Land East of J11, M40, Banbury Supplementary Environmental Information Volume 2: Appendices

Land East of Junction 11 of the M40, Banbury

Transport Assessment Addendum

26th October 2022
SJT/RT/23457-06f Transport Assessment Addendum

JOB TITLE		LAND AT M40 J11		CLIENT		GREYSTOKE	
DRAWING TITLE							
A361 ROUNDABOUT WITH SECONDARY ACCESS							
SCALE	DRAWN BY	DATE	DRAWING No	REVISION			
1:1000@A1	RM	04/10/22	23459-06-01-GA	A

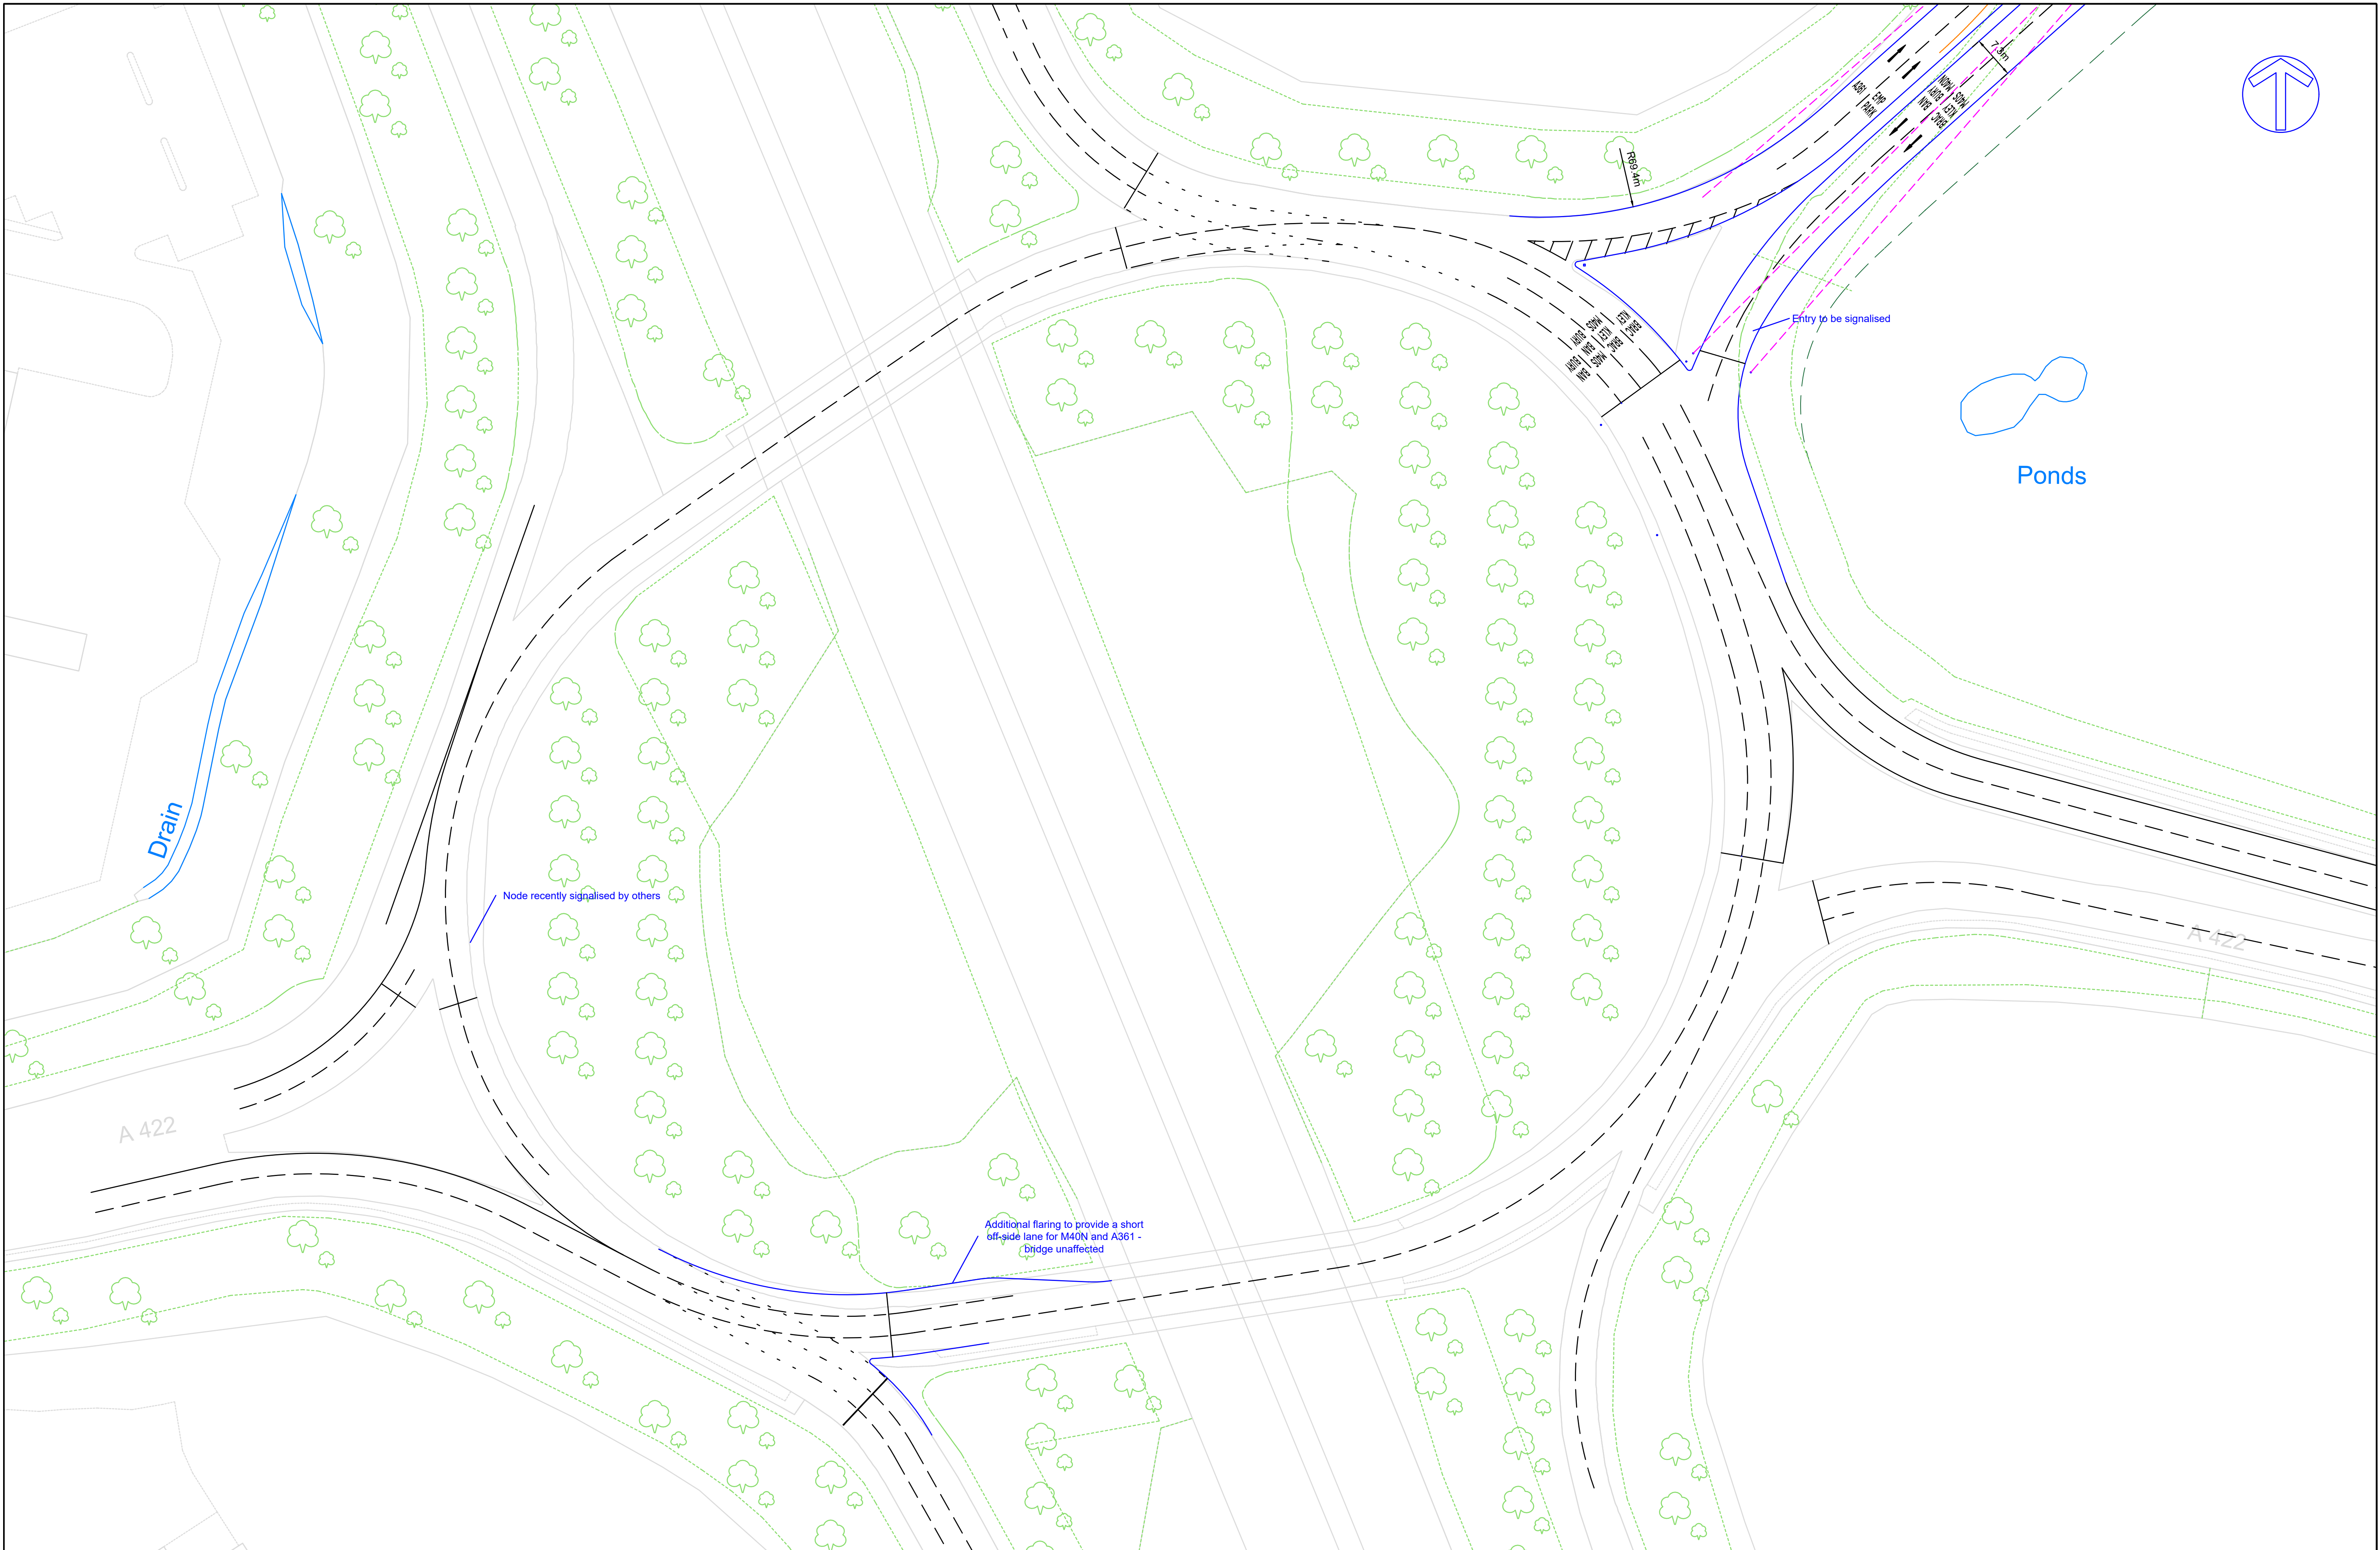
DMRB GG 119 recommends that a Stage 1 Road Safety Audit should be undertaken before planning consent is applied for, but this has not been included. Given the scale of the development and the changes required to the highway layout, a Stage 1 RSA would have been informative.

DMRB GG 119 recommends that a Stage 1 Road Safety Audit should be undertaken before planning consent is applied for, but this has not been included. Given the scale of the development and the changes required to the highway layout, a Stage 1 RSA would have been informative.

- 4.4 The primary access plans can be seen in **Drawing 23457-06a-01-GA** with the tracking shown in **Drawing 23457-06a-03-TRK**.

- 4.5 A Stage 1 Road Safety Audit will be carried out once the VISSIM modelling has been undertaken and any access changes resulting from the outputs have been altered to allow the modelling to show that the proposed development does not show any significant impact on the network.
